RESPONSE TO REQUEST FOR ADDITIONAL INFORMATION

APR1400 Design Certification

Docket No. 52-046

RAI No.: 405-8497
SRP Section: 08.02 – Offsite Power System
Application Section: 08.02
Date of RAI Issue: 02/11/2016

[Figure] Overall differential scheme of MT and UAT in the APR1400

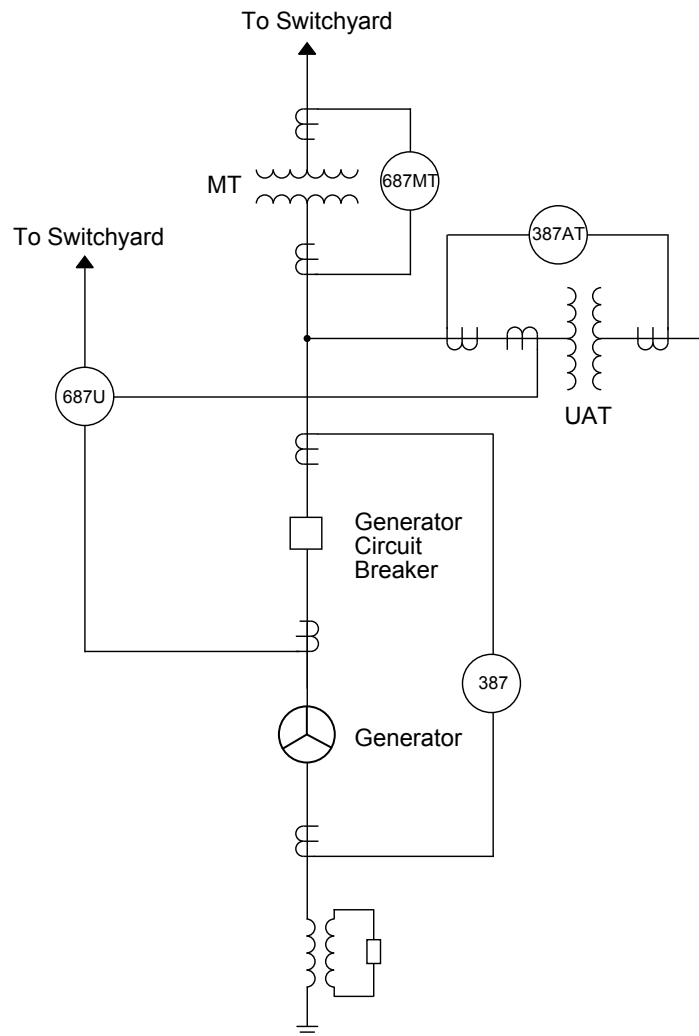
Furthermore, IEEE Std. 666-1991, Section 7.4.2, “Transformer Protection” states that “when the unit service transformer and generator step-up power transformers are connected to the generator terminals, an overall unit differential relay is often provided for backup protection of the equipment. This relay zone includes the neutral side of the generator and the high-voltage side of the unit service and generator step-up and power transformers. Frequently, this zone is extended to include the generator high-voltage circuit breaker(s). A fault occurring anywhere in this zone requires immediate shutdown of the unit.” The applicant stated that device number 87U, the unit overall differential relay, is only provided for the main transformer and not in the list of UAT protective relays. As stated above, IEEE Std. 666-1991 recommends that the relay zone include the high voltage side of the unit service transformer (in the APR1400 design this is defined as Unit Aux Transformer or UAT). Furthermore, DCD Tier 2 Section 8.1.3.3 states that the electric power system is designed to meet industry standards and lists IEEE Std. 242-2001, “IEEE Recommended Practice for Protection and Coordination of Commercial and Industrial Power Systems.” IEEE Std. 242-2001 discusses overall differential backup protection in Section 12.5.3.2.3, such that the overall differential scheme has the capability to detect severe faults. Please discuss why the unit overall differential relay is also not included for the UAT or provide an alternate means of providing generator overall differential protection.

The proposed revision to DCD Tier 2, Section 8.2.1.3 should provide details how the MT, UATs, and SATs protection schemes' are in accordance with the recommendations in IEEE Std. 666-1991. Please provide the list of protective relays for the MT, UATs, and SATs, in the DCD as how the APR1400 design meets the recommendations in IEEE Std. 666-1991.

The protection zone of the unit overall differential relay (687U) in the APR1400 encompasses the high voltage side of UAT as shown in the figure below. This is consistent with the recommendations of IEEE Std. 666-1991.

In order to ensure proper protection of the UAT during a severe fault, the UAT differential protection relay (387AT) includes an unrestrained instantaneous differential overcurrent function that is set above the maximum expected magnetizing inrush current value (e.g., three times rated current), but below the current value that might result in CT ac saturation (e.g., 20 times rated current). Moreover, the overcurrent relay (350/351) is provided for the UAT back-up protection.

Therefore, extension of the unit overall differential protection (687U) zone to the low voltage side of UAT is not necessary.
